The following information changes the competitive process documents issued on January 30, 2025.

ADDENDUM #
E-2

PROJECT NAME:
HWDSB Parkdale ES Accessibility

PARKDALE ELEMENTARY SCHOOL ACCESSIBILITY
RENOVATIONS
GROUND FLOOR DEMOLITION RCP
(REFERENCE: 1/A1.10)

**ADD-3
SK-01**

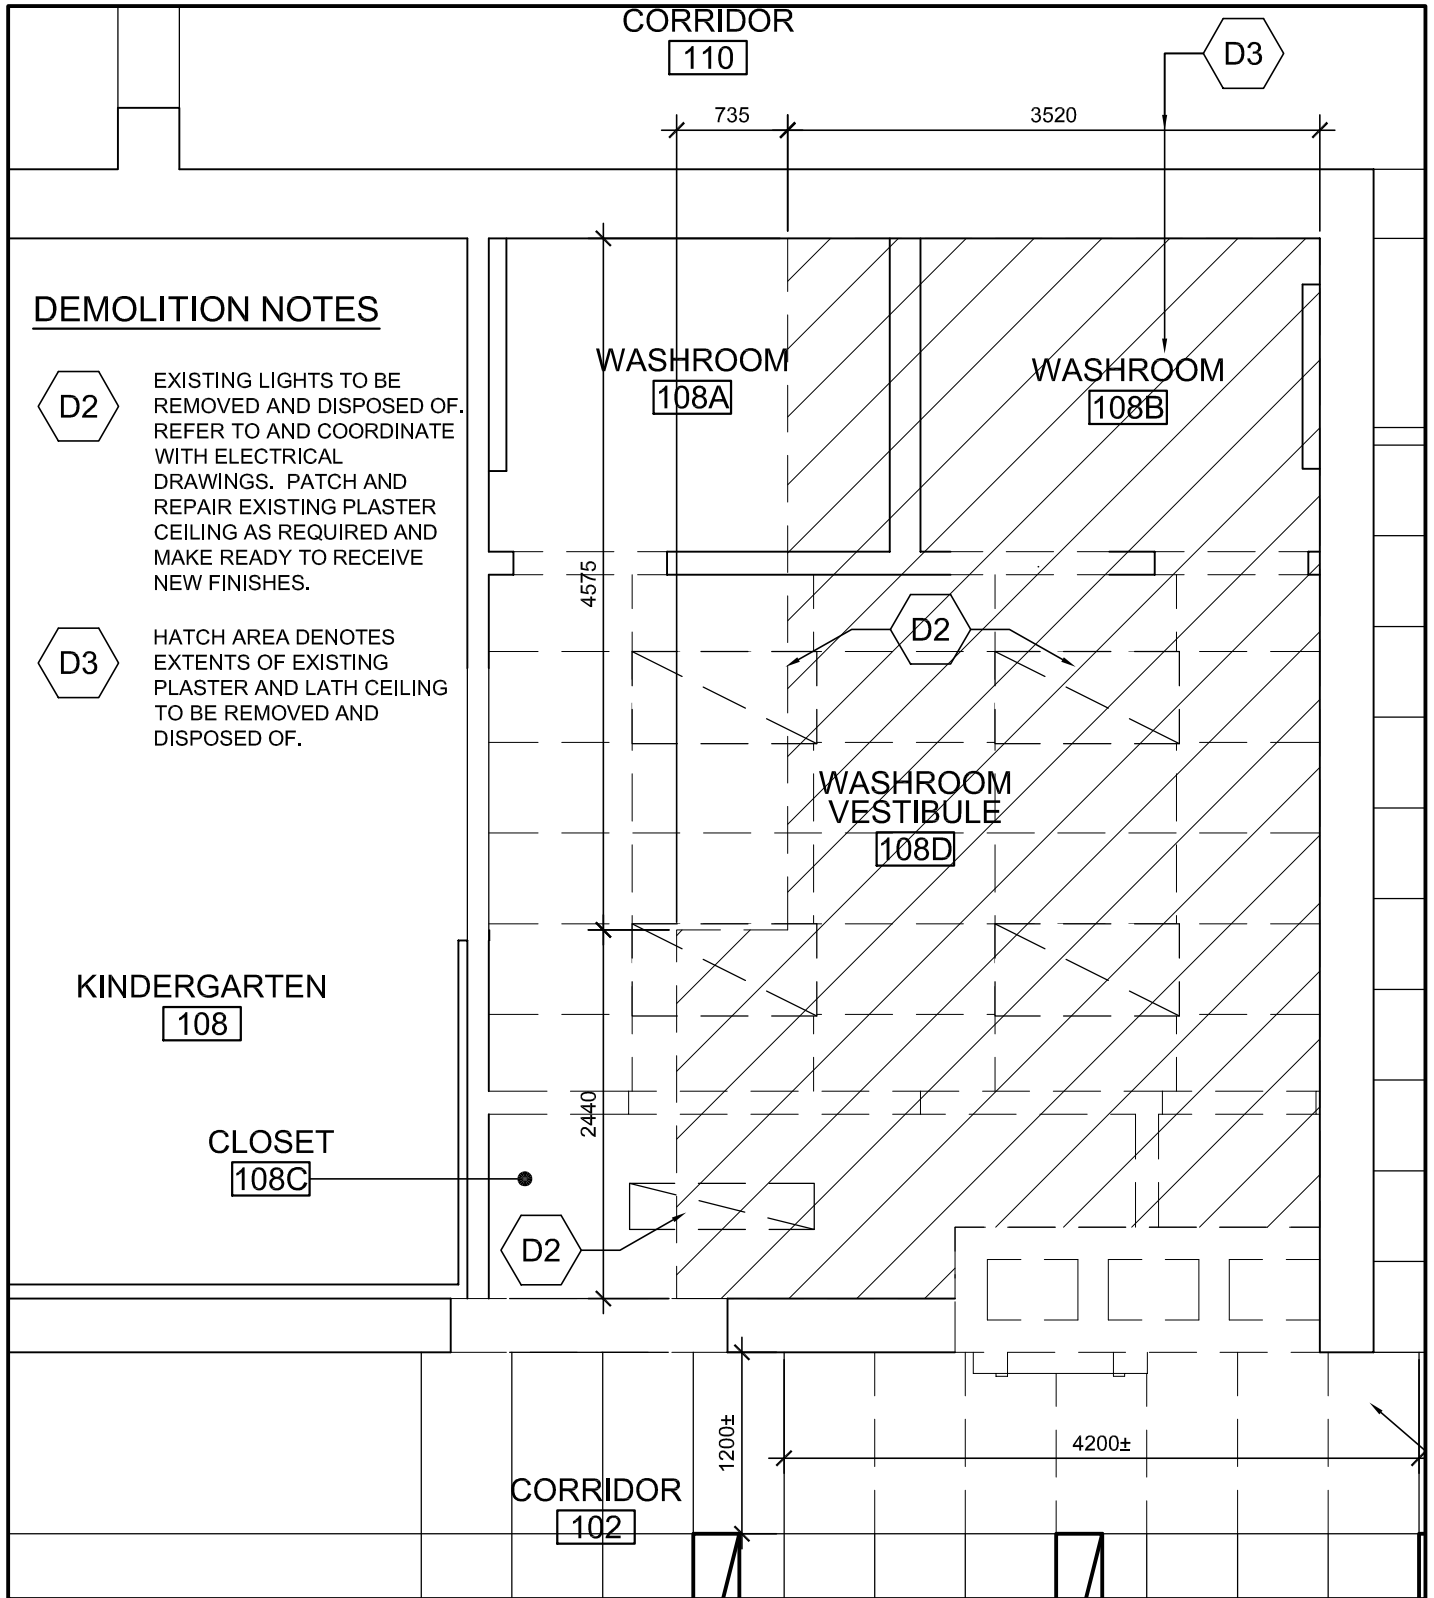
- Item 1** In washrooms 108A, 108B and washroom vestibule 108D, allow for the removal of the existing plaster ceiling as shown in included sketch SK-01 to allow for the installation of the 2nd floor structural steel beams.. Allow for the reinstallation of 2 layers of 16mm type 'x' gypsum board on 22mm metal hat channels at 400mm o/c in the area of the removed plaster as shown in sketch SK-02. Allow for the temporary removal and reinstallation of the existing light fixtures in washroom 108A and 108B.

1 PARTIAL GROUND FLOOR REFLECTED CEILING PLAN
A1.35 SCALE 1:50

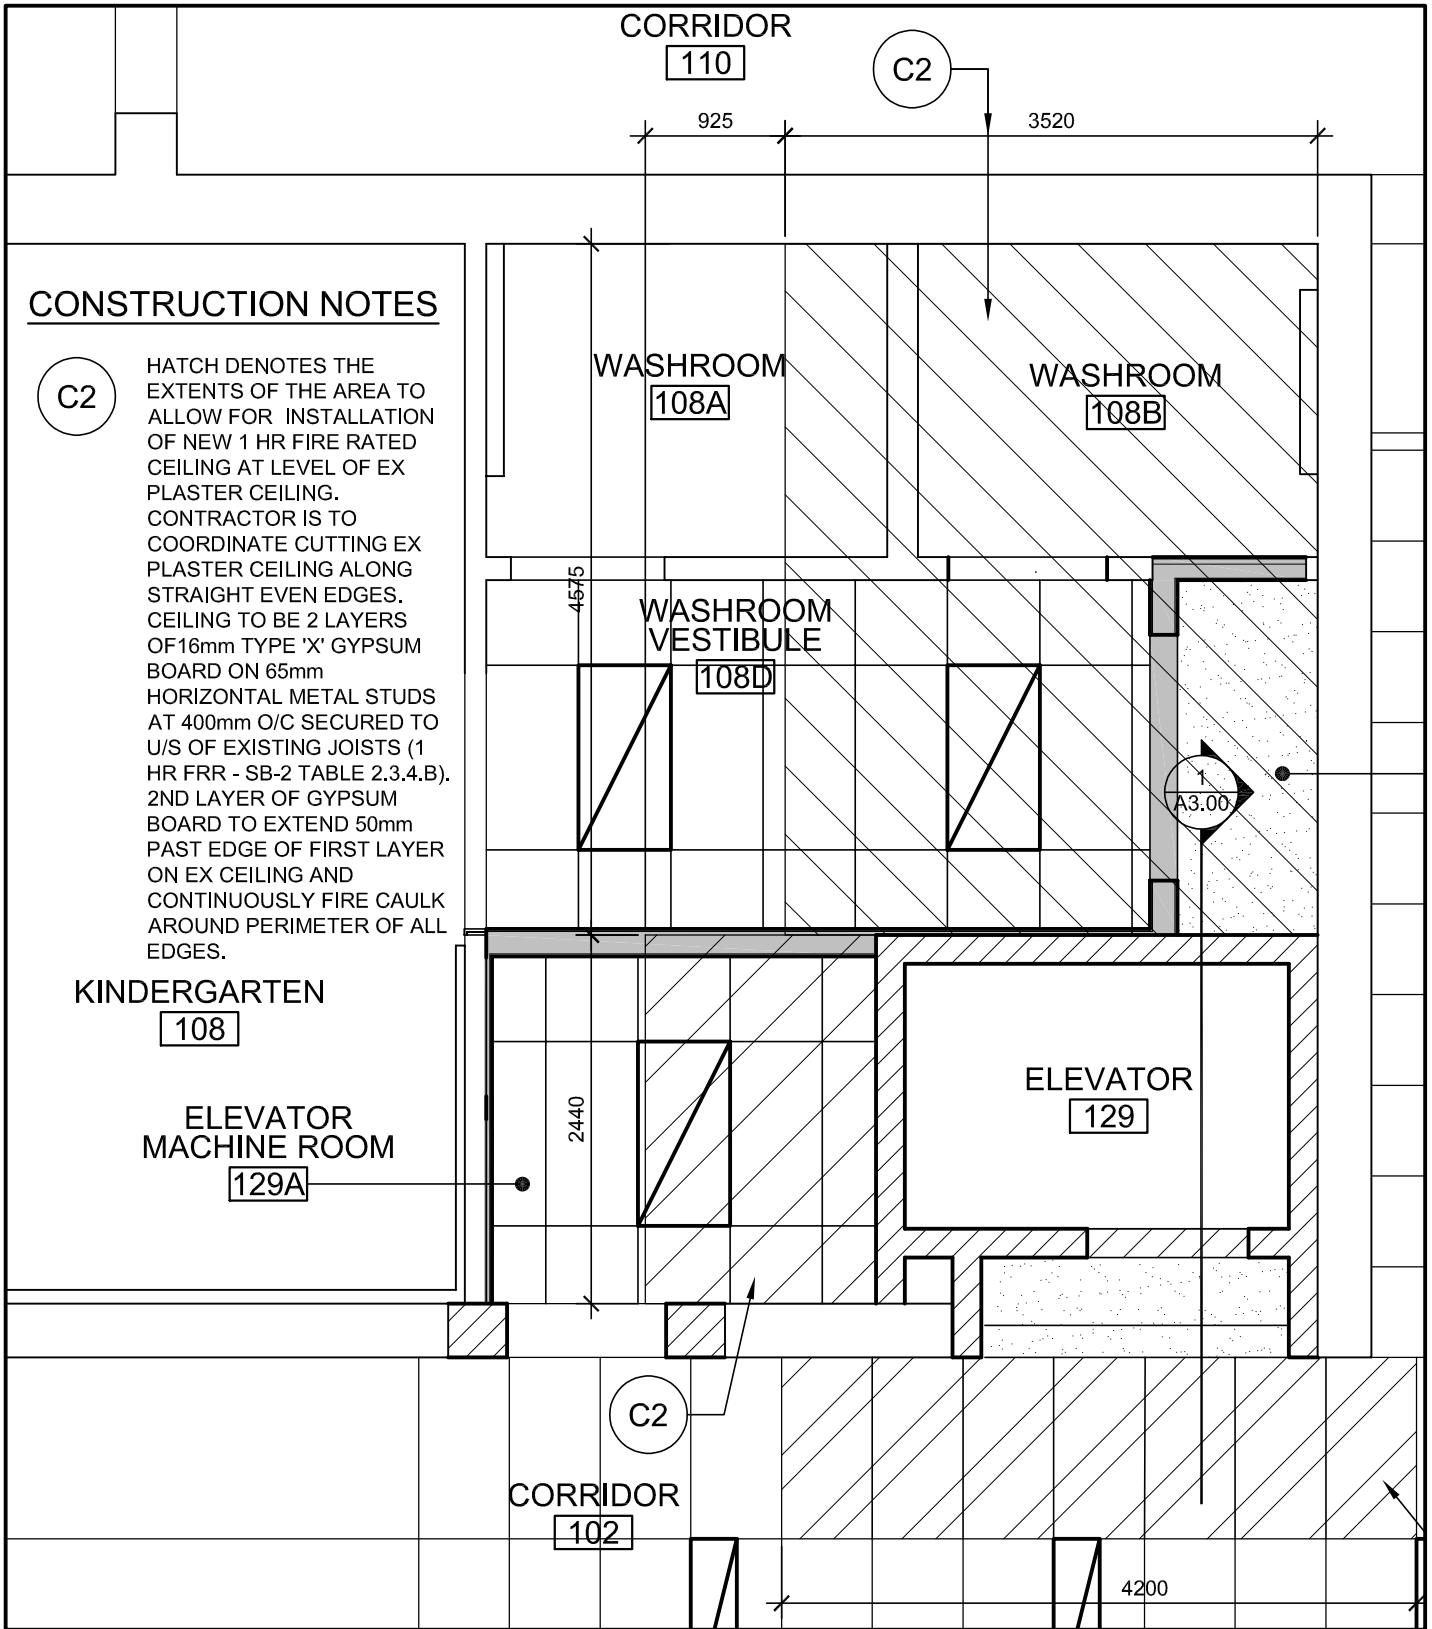
C2 HATCH DENOTES THE EXTENTS OF THE AREA TO ALLOW FOR INSTALLATION OF NEW 1 HR FIRE RATED CEILING AT LEVEL OF EX PLASTER CEILING. CONTRACTOR IS TO COORDINATE CUTTING EX PLASTER CEILING ALONG STRAIGHT EVEN EDGES. CEILING TO BE 2 LAYERS OF 16mm TYPE 'X' GYPSUM BOARD ON 65mm HORIZONTAL METAL STUDS AT 400mm O/C SECURED TO U/S OF EXISTING JOISTS (1 HR FRR - SB-2 TABLE 2.3.4.B). 2ND LAYER OF GYPSUM BOARD TO EXTEND 50mm PAST EDGE OF FIRST LAYER ON EX CEILING AND CONTINUOUSLY FIRE CAULK AROUND PERIMETER OF ALL EDGES.
